# TOWN OF JONESBOROUGH Town Hall Board Room 123 Boone Street Jonesborough, TN 37659

The Jonesborough Tree and Townscape Board will meet at 10:00 a.m., Thursday, December 18, 2025, in the Board Room at Town Hall, 123 Boone Street, Jonesborough, TN, to consider the following agenda:

DATE: December	18 <sup>th</sup> , 2025	AGENDA ITEM #:	4
SUBJECT:	<mark>REVISED</mark> BRADFORD PA	ARK LANDSCAPE PLAN

C5.0

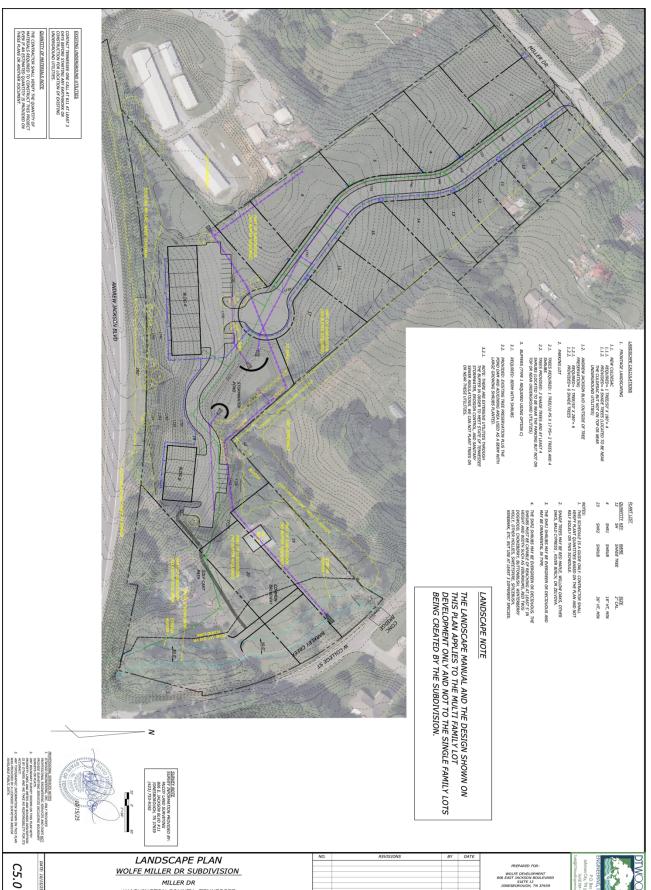
The only required buffering is located along the Northern border of the multi-family residential development, low impact, due to the no impact use R-1 zone abutting the proposed use. As stated in the landscape requirements, a low impact use abutting a no impact use will require a type one buffer.

Provided: Type one buffer option C, berms with shrubs. This buffer will limit any interference with existing utilities within this area. The provided buffer along with the existing vegetation will result in a more than adequate buffer. Twenty-three (23) shrubs have been provided for berm vegetation.

Road frontage is required along the new cul-de-sac and Andrew Jackson Blvd. Cul-de-sacs are considered a public roadway, thus requiring road frontage landscaping. The cul-de-sac measures 180 linear feet. 1 tree/50' x 180' = 4 shade trees. Andrew Jackson Blvd. measures 280 linear feet of road frontage. 1 tree/50' x 280' = 6 shade trees.

The parking lot for this development contains 17 parking spaces. Parking lot landscaping is required at 20 parking spaces; however, parking lot landscaping has been provided. 1 tree/10 PS x 17 PS = 2 shade trees and 4 shrubs (2 per tree). Shade trees may be either Red Maple, Willow Oak, River Birch, Bald Cypress, Zelkova, or other oak species.

Two (2) shade trees and four (4) shrubs were provided. Shade trees may be Red Maple, Willow Oak, River Birch, Bald Cypress, Zelkova, or other oak species. Shrubs must be capable of reaching 5' in height and width and may be viburnums, red twig

The landscape plan exceeds the requirements of T & T landscape ordinance with no variances.

**Motion:** Lori Rosenoff made the motion to approve the landscape plan for Wolfe-Miller Subdivision as presented, seconded by Terry Countermine and passed unanimously.

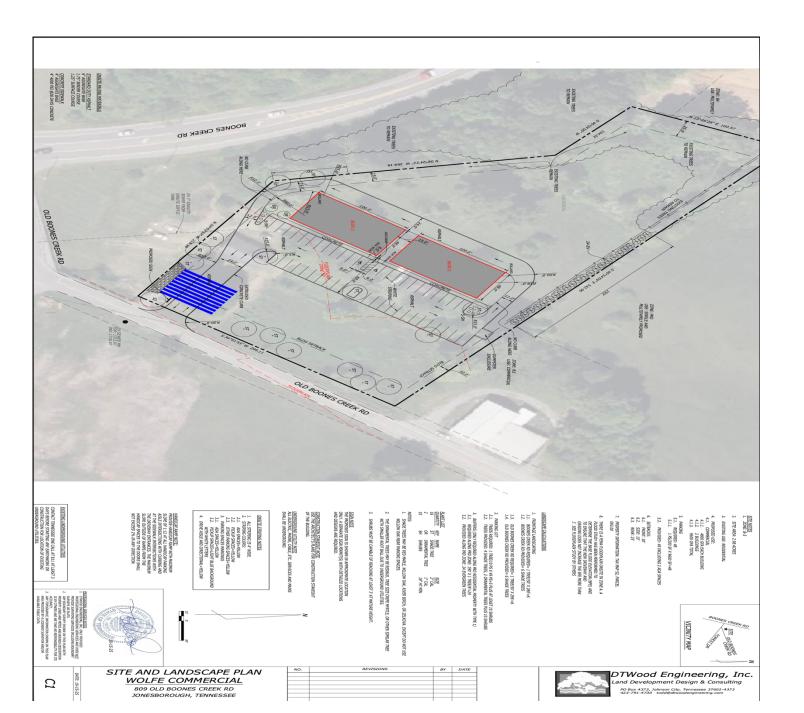
The only required buffering will be located along the Northwest property line of the property for 190 linear feet. The proposed commercial use of the Wolfe property will abut proposed single and multifamily use property. The medium impact will be required to implement a type 1 buffer from the edge of the existing vegetation to the next commercial use property line as seen on the site plan for a total of 190'. Type 1, option A1 requires 1 tree per every 8'. 1 tree/8' x 190' = 24 evergreen trees.

Provided: Twenty-four (24) evergreen trees spaced no more than 8' apart.

Road Frontage is required along Boones Creek Rd. and Old Boones Creek Rd. along the eastern and southwestern property boundaries. The total linear footage for both boundaries equals 584 linear feet. 1 tree/50' x 584 = 12 shade trees.

Provided: 12 shade trees dispersed adequately along the property lines requiring road frontage. Shade trees may be red maple, willow oak, river birch, or zelkova.

The parking lot provided has forty-nine (49) parking spaces. The required landscaping for a parking lot with 20 or more spaces is 1 tree/10' with 2 shrubs per tree. 1 tree/10' x 49 = 5 trees and 10 shrubs. Shade trees may be red maple, willow oak, river birch, or zelkova. Shrubs must be capable of reaching at least 3' at mature height. Ornamental trees may be redbud, tree size crepe myrtle, or other similar tree with smaller root ball due to underground utilities.

Provided: Four (4) shade trees, two (2) ornamental trees, and ten (10) shrubs.

<u>Summary:</u> The landscape plan exceeds the requirements of T & T landscape ordinance with no variances.

**Motion:** Melinda Copp made the motion to approve the landscape plan for Wolfe Commercial Development as presented, seconded by Goeffrey Hoare and passed unanimously.
